NHTSA: 25V-180

Winnebago Towable: CAM0000042

SUBJECT: Incorrect Tire Information on Placard

Incorrect Tire Information on Placard

Incorrect Tire Information on Placard

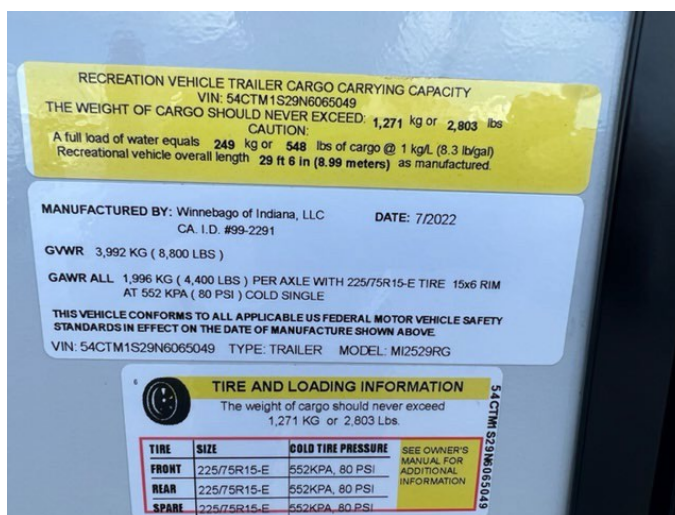
Winnebago has decided that certain 2025 Access and Voyage travel trailers that fail to conform to Federal Motor Vehicle Safety Standard No. 110, "Tire Selection and Rims." The Federal Identification Label and Tire Loading Information Placard has the incorrect tire inflation listed. These vehicles were produced **April 18, 2024** through **December 18, 2024**.

Incorrect tire inflation information can result in improperly inflated tires and cause tire failure, increasing the risk of a crash.

1. **Remove the existing labels; a blow dryer or heat gun can assist in removal.**

2. **Clean the area and wipe dry. Once surface is prepped and dried apply new FED ID Tag and Tire Information Placard.**
3. **Submit a warranty claim or return the provided pre-paid post card.**
